BID ADDENDUM NO. 1

PROJECT NAME: KING STREET ELEMENTARY SCHOOL
BOILER REPLACEMENT
SED #: 66-19-04-03-0-007-015

DATE: February 16, 2023

DRAWING KSES H301 – KING ST ES DETAILS AND SCHEDULES

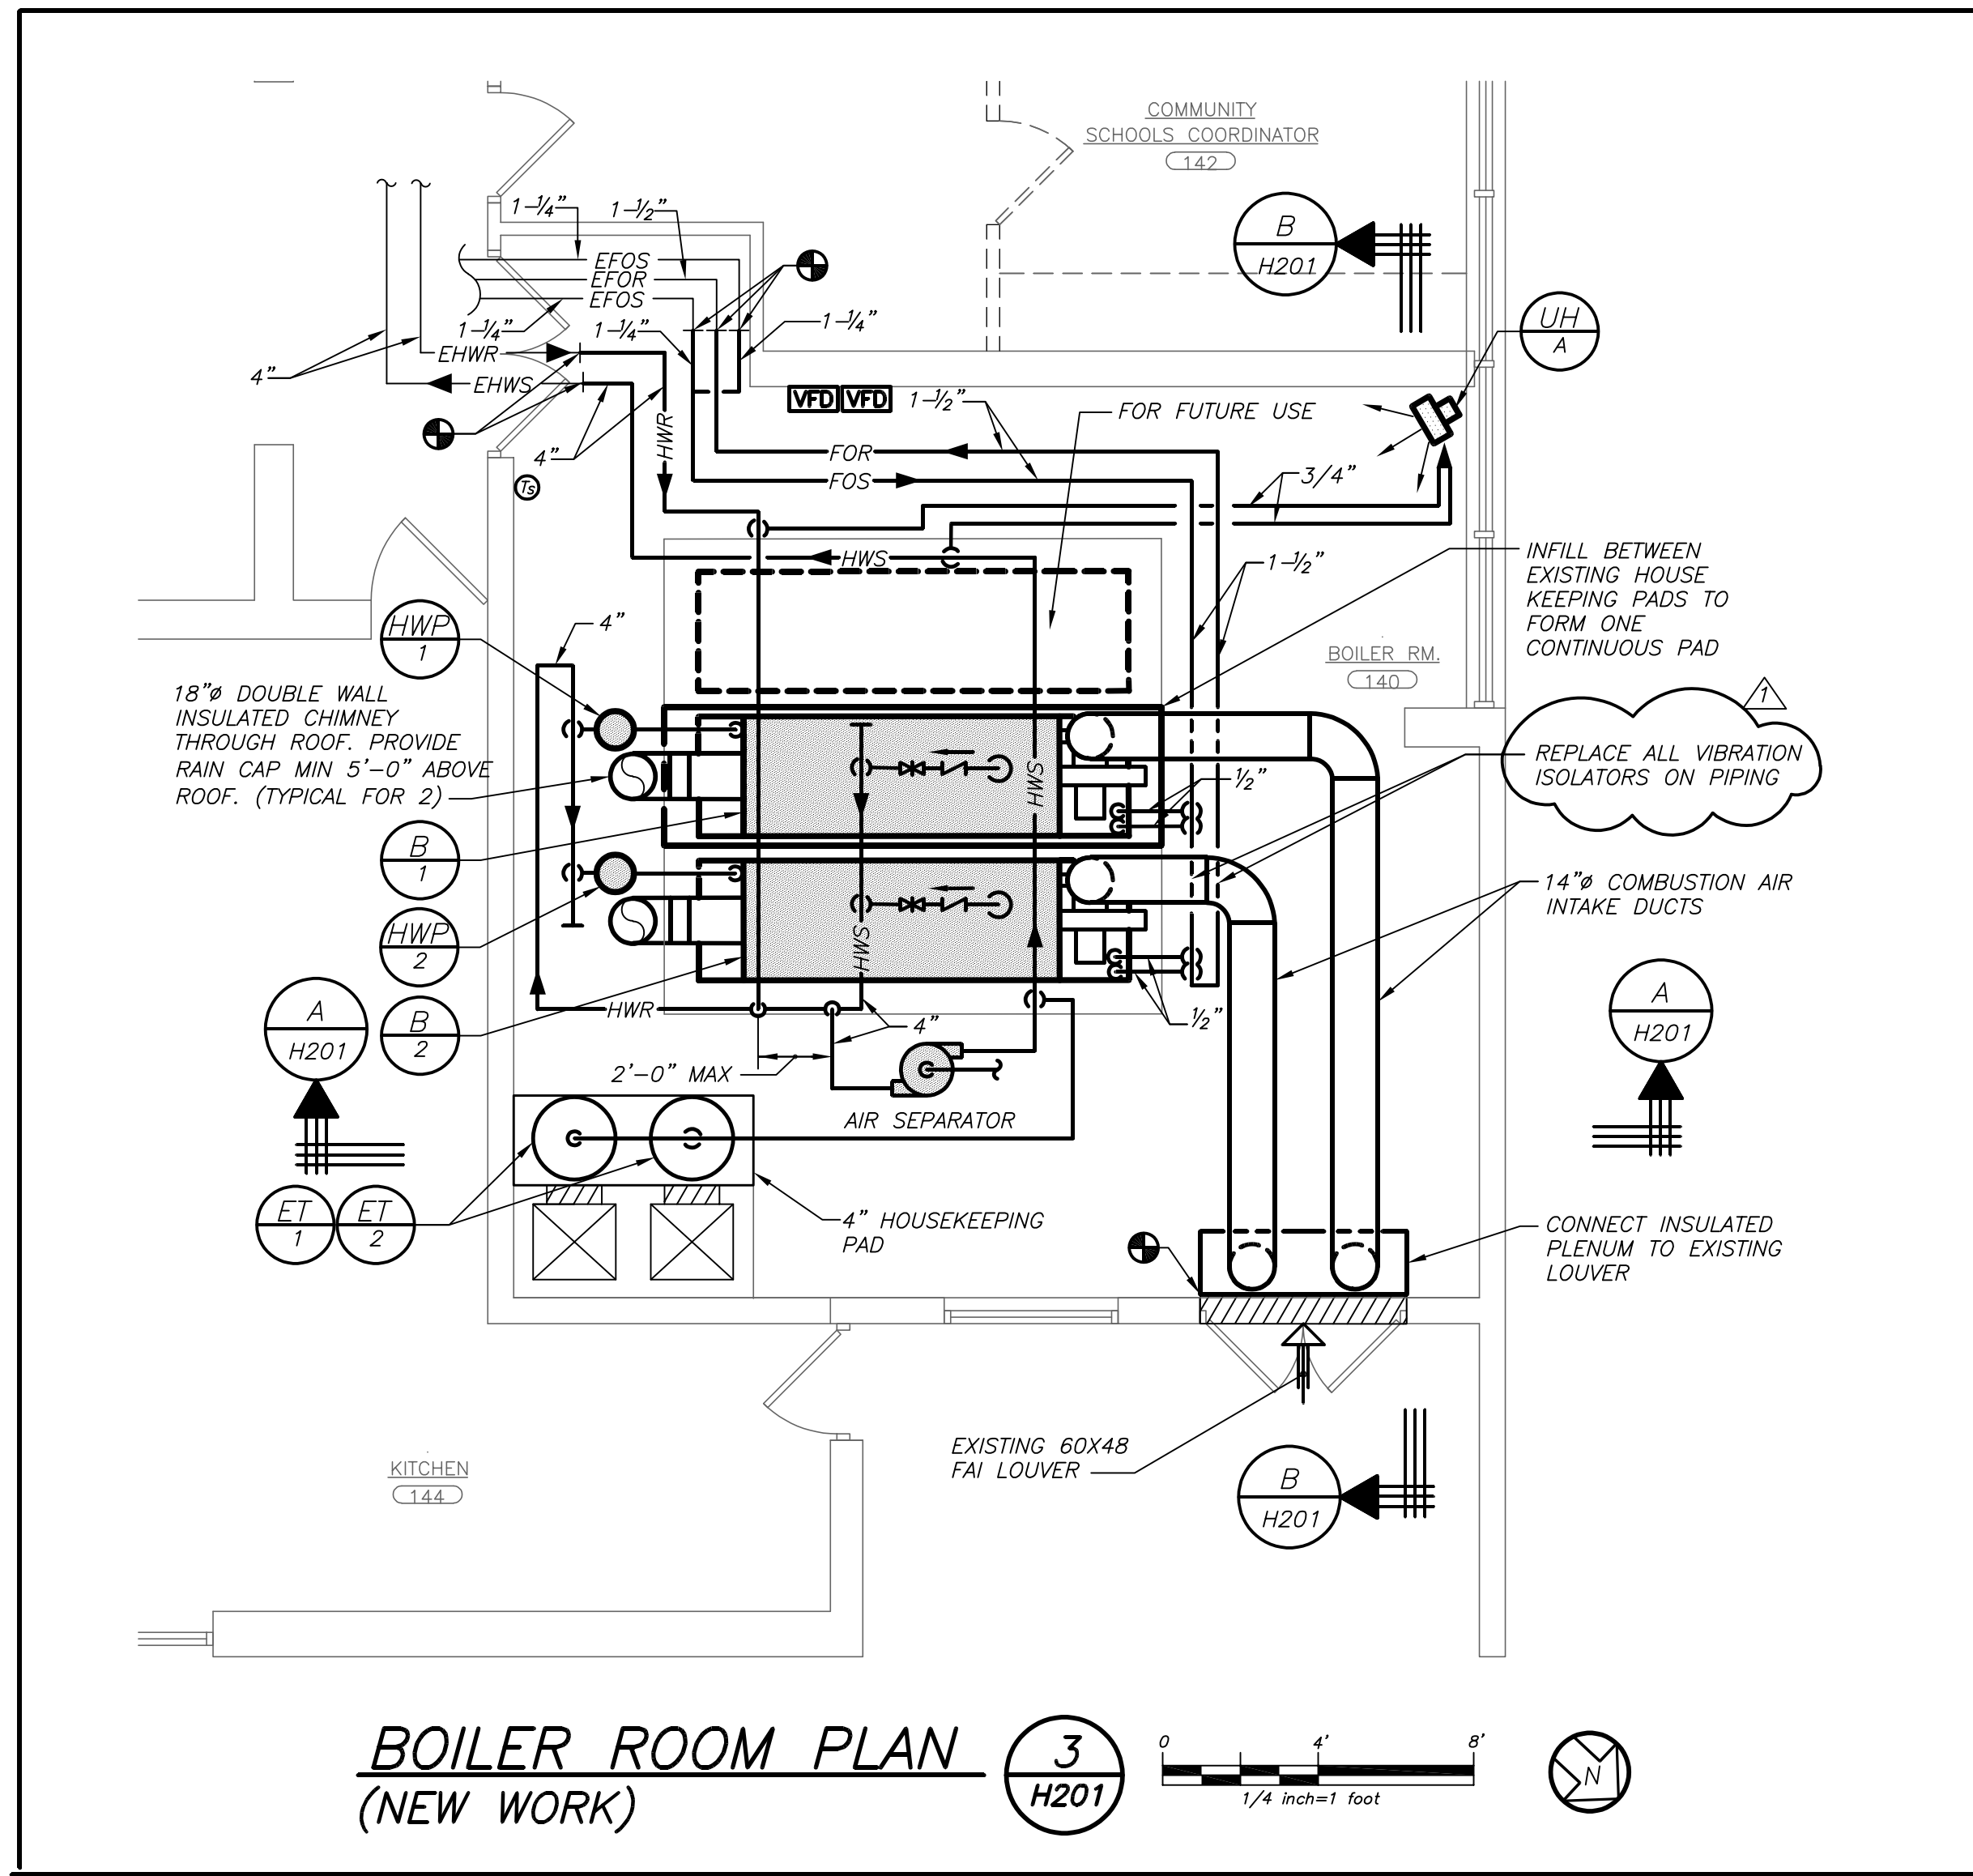
- 1. 1/H201 – BOILER ROOM PLAN (REMOVALS)
 - a. Include note “Boiler gaskets and burner lining shall be removed by abatement contractor pending ACM report.
Coordinate with abatement contractor”. See attached drawing.
- 2. 2/H201 – FAN ROOM PLAN (NEW WORK)
 - a. Modify note for Alternate MC-1 to include chemical feeder. See attached drawing.
- 3. 3/H201 – BOILER ROOM PLAN (NEW WORK)
 - a. Include note “Replace all vibration isolators on piping”. See attached drawing.
- 4. 4/H201 – PUMP STATION PIPING SCHEMATIC (ALTERNATE)
 - a. Replace tags HWP-1 and HWP-2 with HWP-3 and HWP-4. See attached drawing.
